NOTICE OF DECISION
Site Design Review for Lyrics Cafe – Commercial Remodel
File No. DR223-0003 – 808/814 E Hancock Street

Site Design Review for Lyrics Cafe – Commercial Remodel File No. DR223-0003 – 808/814 E Hancock Street

FILE NO: DR223-0003

REQUEST: Remodel café/coffee shop

Existing
Drive-Thru
Remodeled

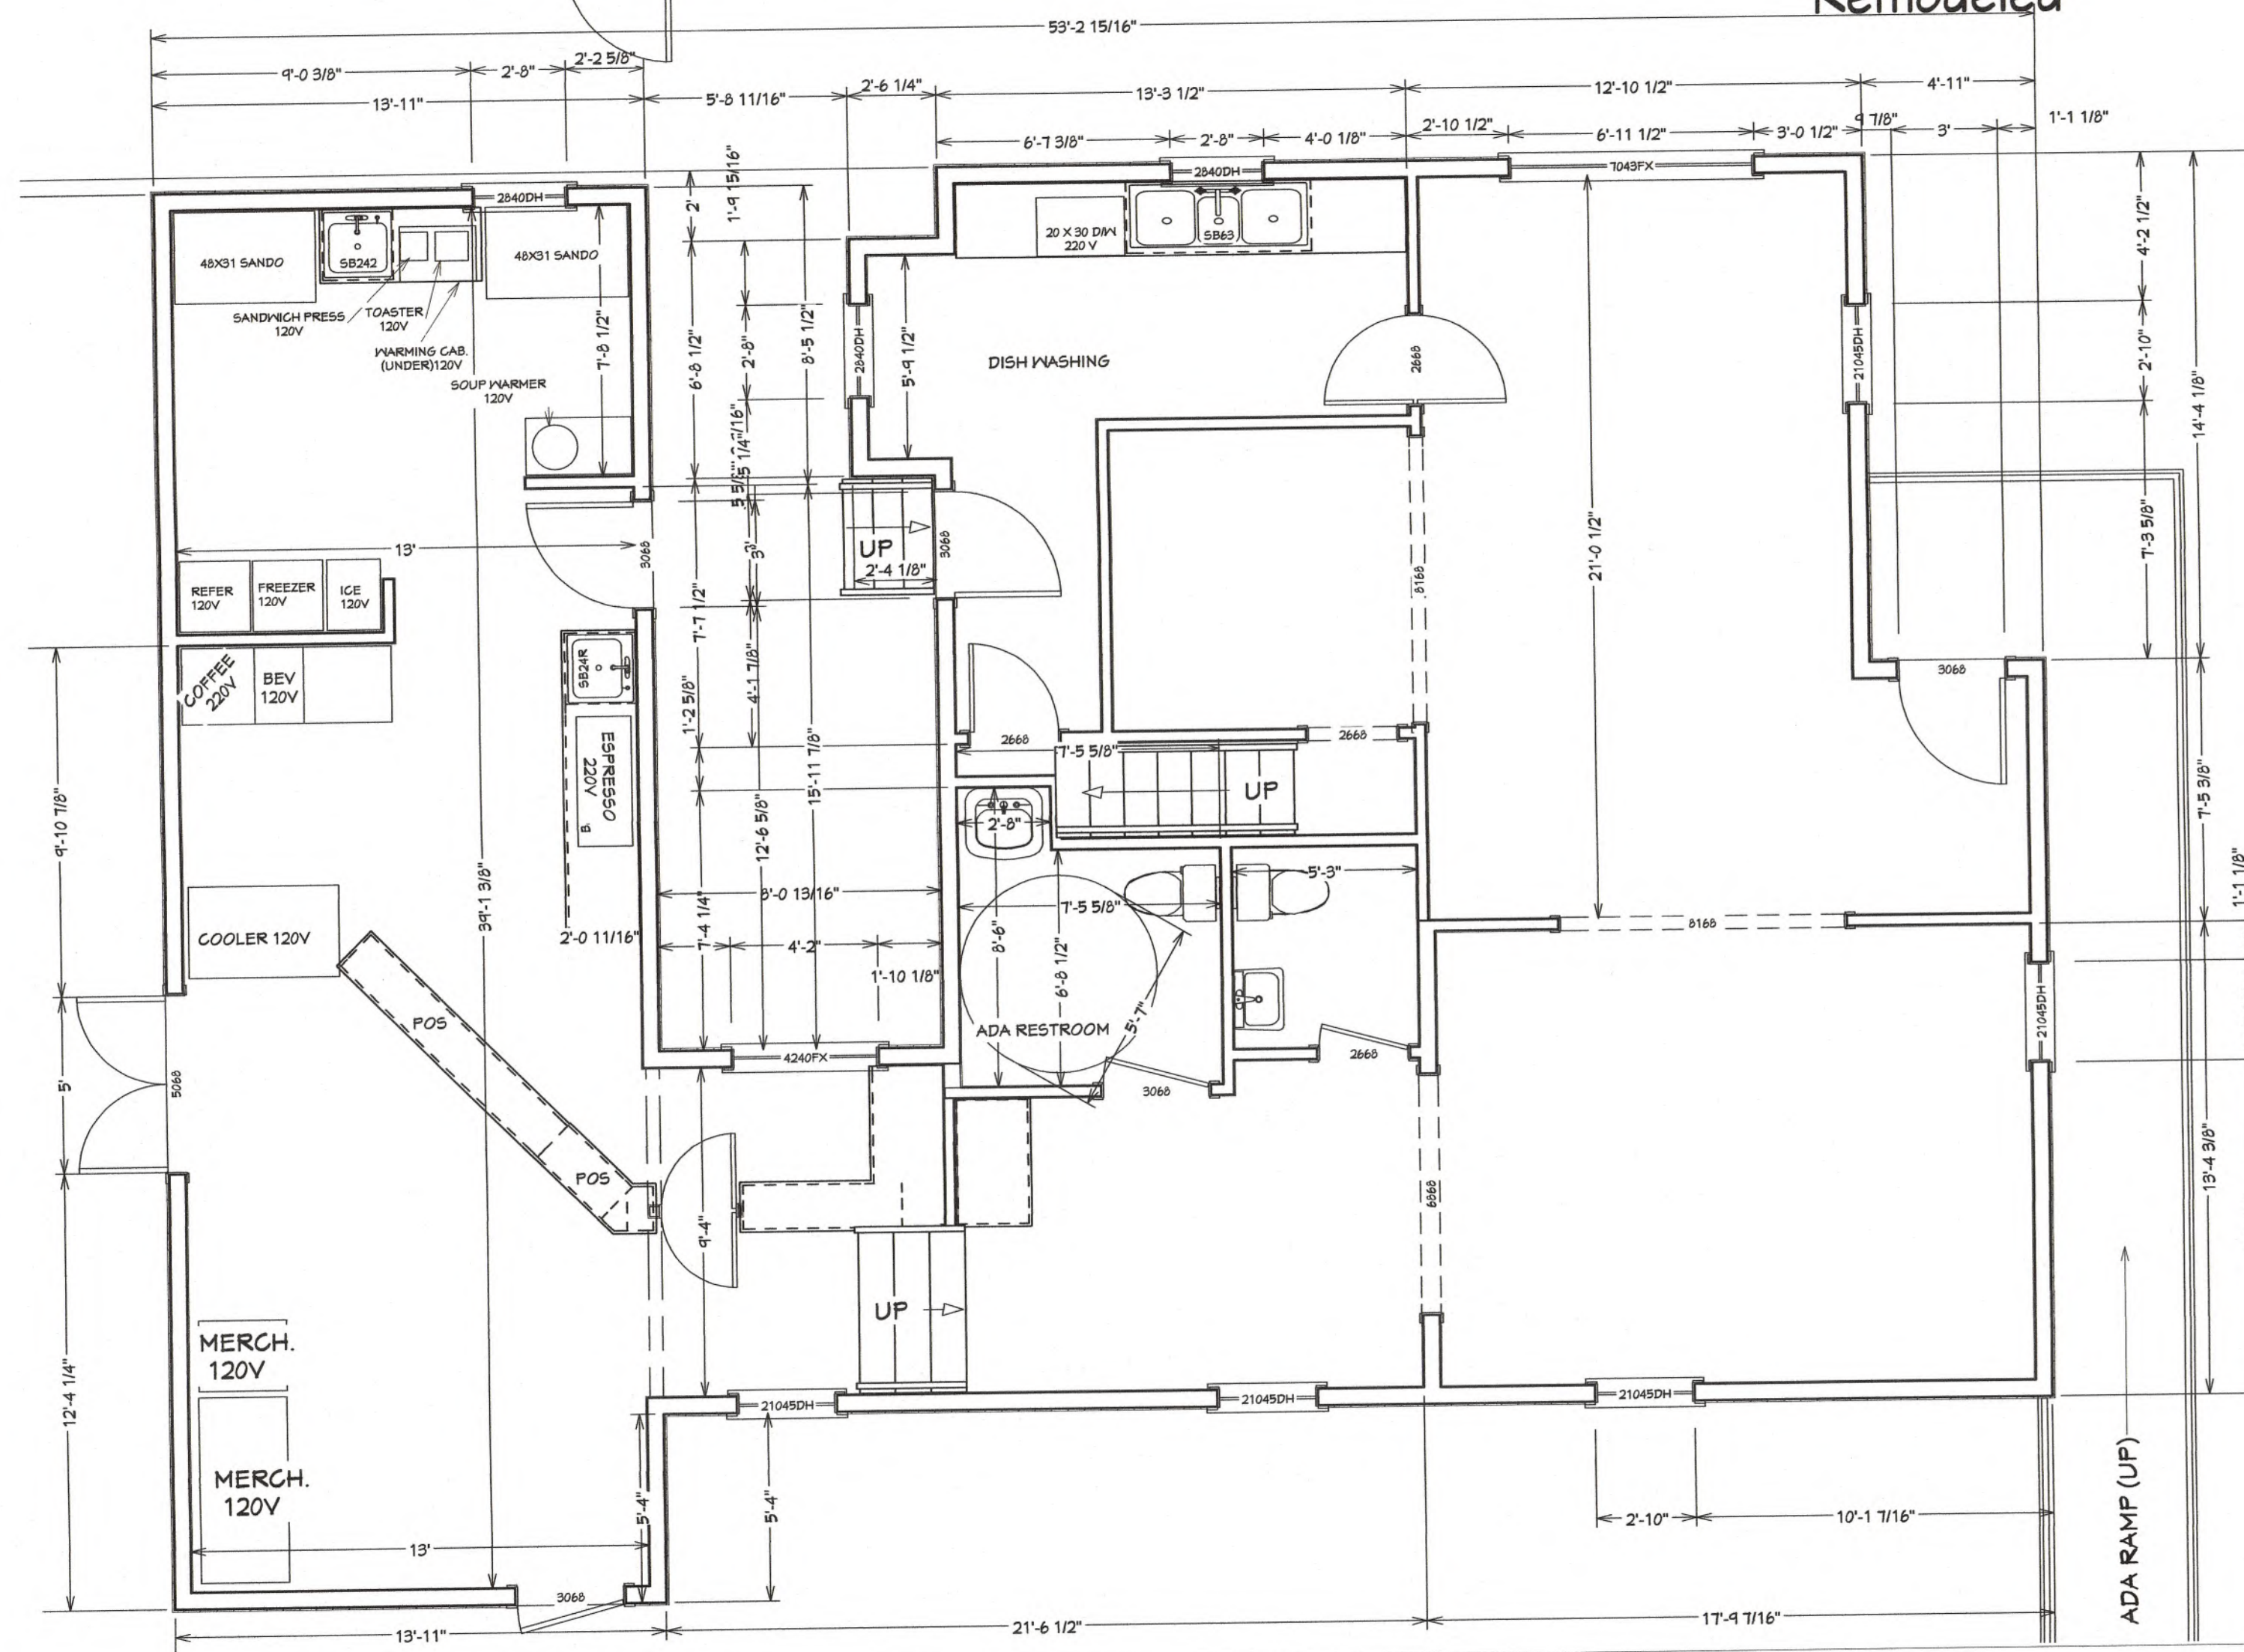
The application materials (narrative and Sheet 3) indicate that removal of the chimney/fireplace in Building 1 will occur. However, conflicting application materials (building elevations, Sheet A2) indicate that the chimney for Building 1 will remain in place. Because the discrepancy exists within submitted application materials (Sheet 3 and Sheet A2) of the application materials, prior to issuance of building permits for the building at 808 E Hancock Street, the Applicant shall either submit revised building elevations that depict the roof configuration with the chimney removed or submit revised building plans that depict retention of the chimney/fireplace.

3. **Revision of Plans for Building Permits:** Prior to issuance of building permits for the building at 808 E Hancock Street, the Applicant shall either submit revised building elevations that depict the roof configuration with the chimney removed or submit revised building plans that depict retention of the chimney/fireplace.
